POINT BEACH NUCLEAR PLANT UNIT 1

AMENDMENT TO FACILITY OPERATING LICENSE

Amendment No. 3  
License No. DPR-24

CHANGE NO. 8 TO APPENDIX A OF TECHNICAL SPECIFICATIONS

Figure 15.2.1-1 Core DNB Safety Limits  
Point Beach 1 - Cycle 3

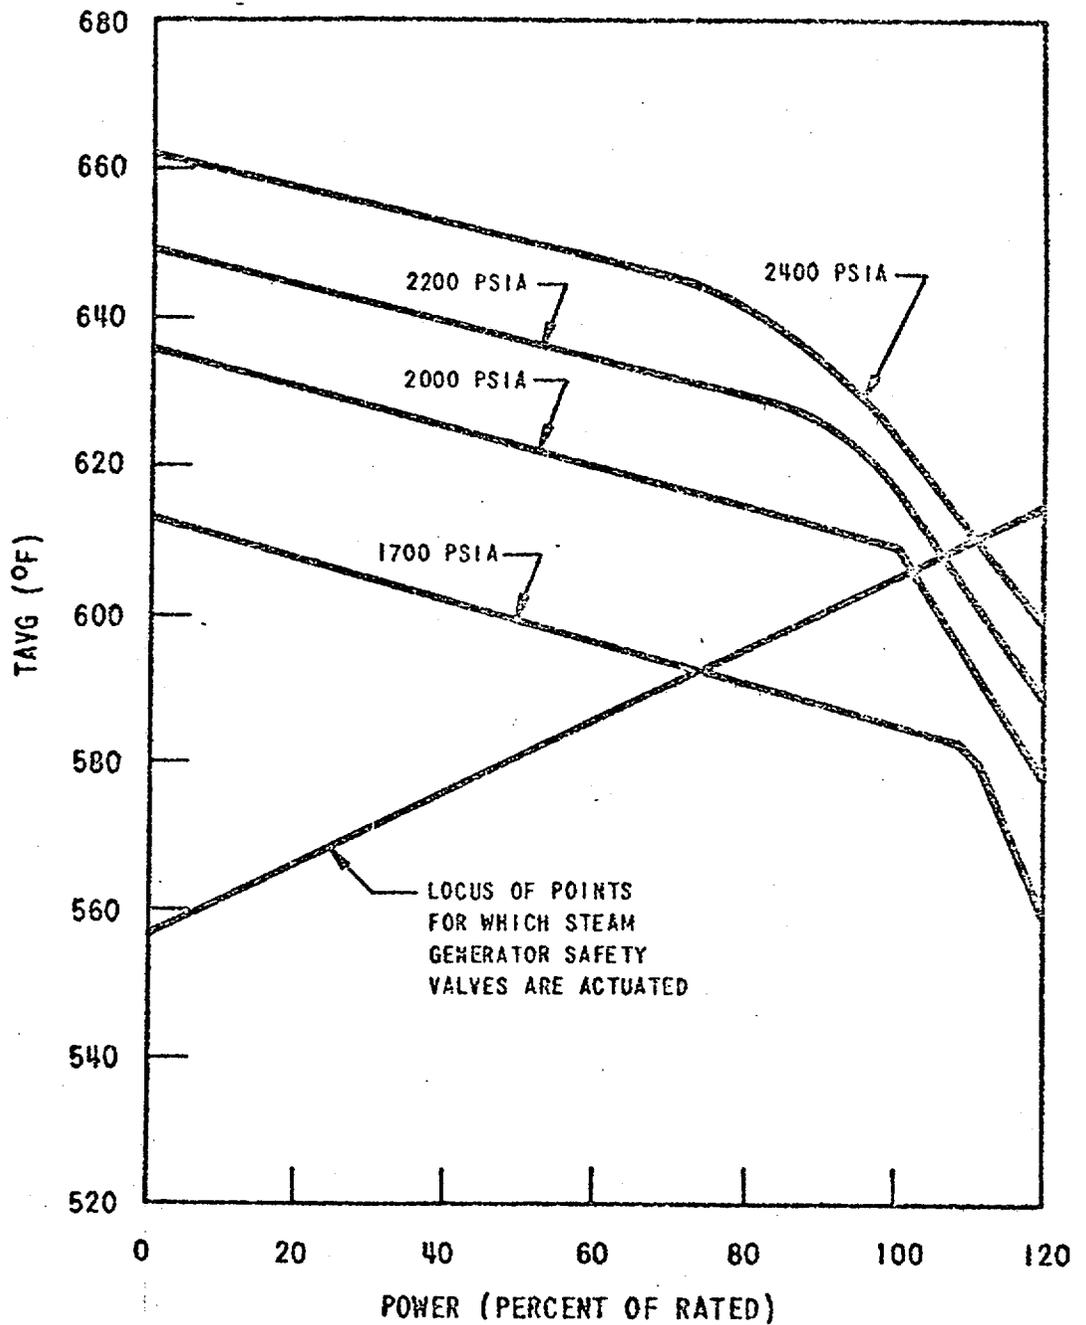
Delete pages 15.2.1-1, 15.2.1-3, 15.2.3-2, 15.2.3-3, 15.2.3-6, 15.2.3-7, 15.3.10-1, 15.3.10-2, 15.3.10-5, 15.3.10-6, 15.3.10-7, 15.3.10-8, 15.3.10-10, and 15.3.10-11 and replace with the attached revised pages. Also delete Figure 15.2.1-1 and Figure 15.3.10-1 and replace with the attached revised figures.

1. The combination of thermal power level, coolant pressure, and coolant temperature shall not exceed the limits shown in Figure 15.2.1-1. The safety limit is exceeded if the point defined by the combination of reactor coolant system average temperature and power level is at any time above the appropriate pressure line.
2. Unit 1, Cycle 3 shall be limited to 6,000 effective full power hours (EFPH) under design operating conditions, with a primary system pressure of 2000 psia.

Additional peaking factors to account for local peaking due to fuel rod axial gaps and reduction in fuel pellet stack length as well as a penalty to account for rod bowing, have been included in the calculation of the curves shown in Figure 15.2.

These curves are based on an  $F_{\Delta H}^N$  of 1.58, cosine axial flux shape, and a DNB analysis as described in Section 4.3 of WCAP-8050 "Fuel Densification, Point Beach Nuclear Plant Unit 1 Cycle 2," (including the effects of fuel densification and flattened cladding).

Figure 15.2.1-1 also includes an allowance for an increase in the enthalpy rise hot channel factor at reduced power based on the expression:

$$F_{\Delta H}^N = 1.58 [1 + 0.2 (1-p)] \text{ where } P \text{ is a fraction of rated power}$$

when  $P \leq 1.0$ .  $F_{\Delta H}^N = 1.58$  when  $P > 1.0$ .

FIGURE 15.3.10-1

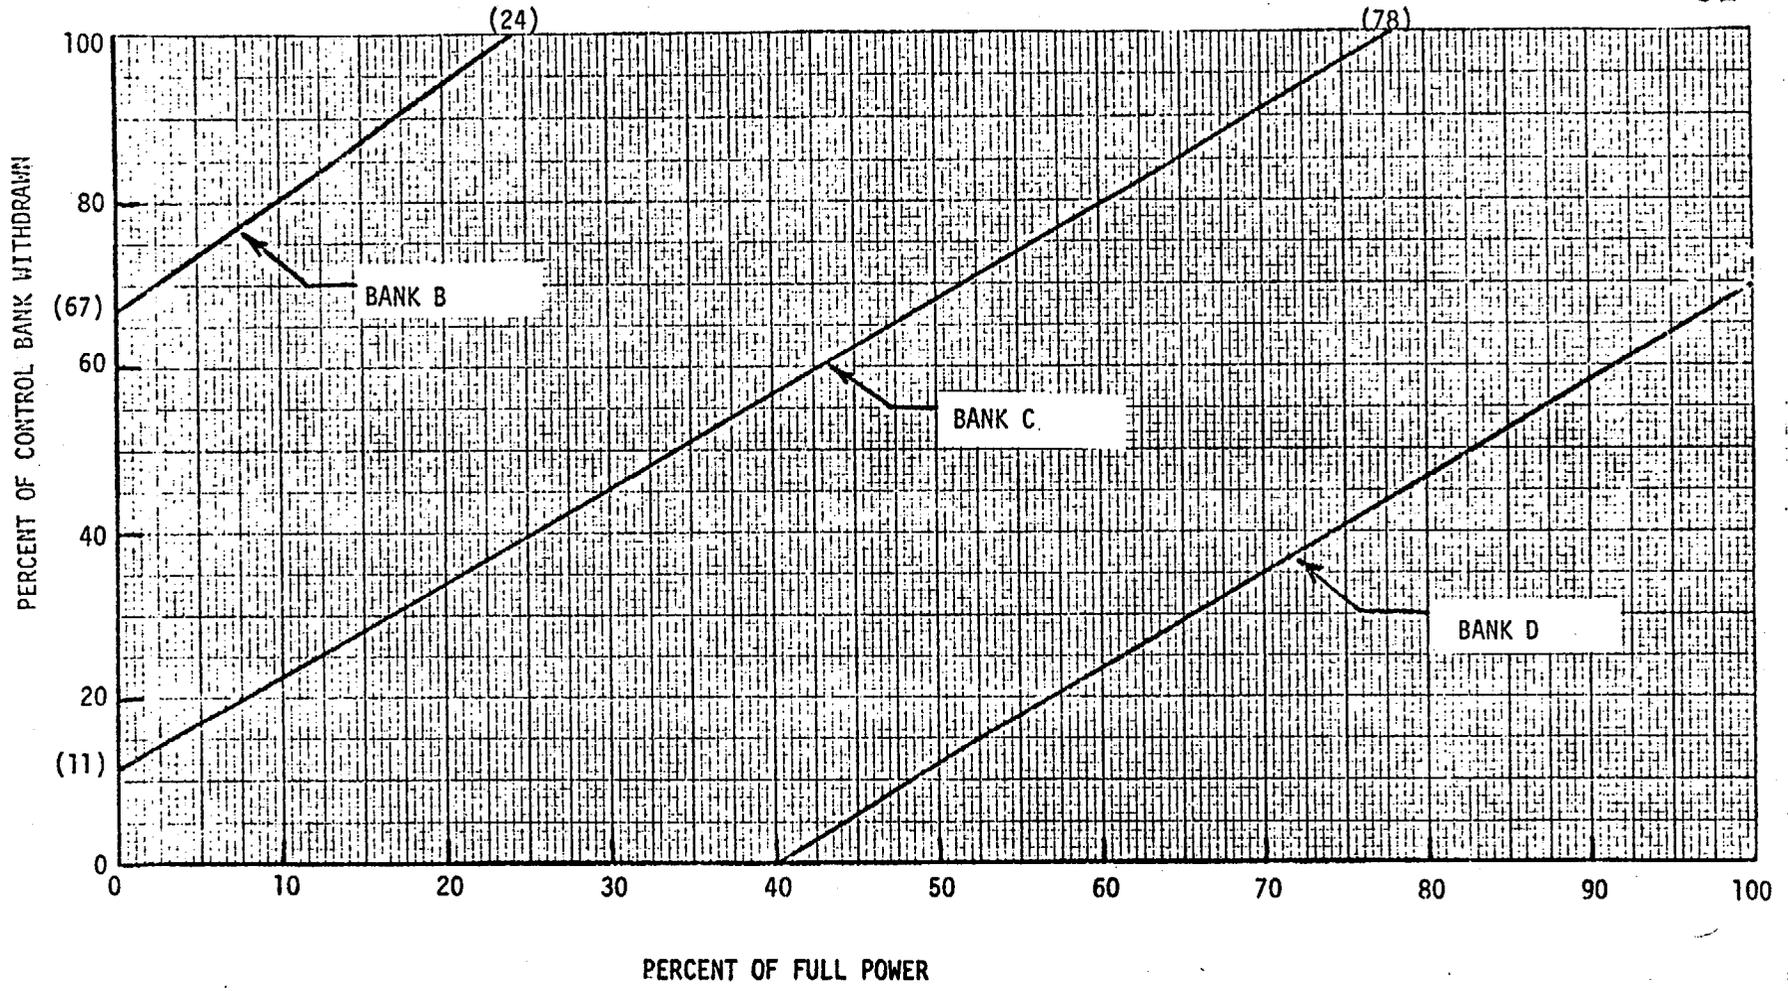
2. When the reactor is critical, the control rods shall be inserted no further than the limits shown by the lines on Figure 15.3.10-1 and the shutdown margin with allowance for a stuck rod shall exceed the applicable value shown on Figure 15.3.10-2 under all steady state operating conditions from zero to full power, including effects of axial power distribution. The shutdown margin as used here is defined as the amount by which the reactor core would be subcritical at hot shutdown conditions if all control rods were tripped, assuming that the highest worth control rod remained fully withdrawn and assuming no changes in xenon, boron, or part length rod position. Exceptions to the insertion limit and stuck rod requirements only are permitted for physics tests and control rod exercises.

The specified control rod insertion limits have been revised to limit the potential ejected rod worth in order to account for the effects of fuel densification.
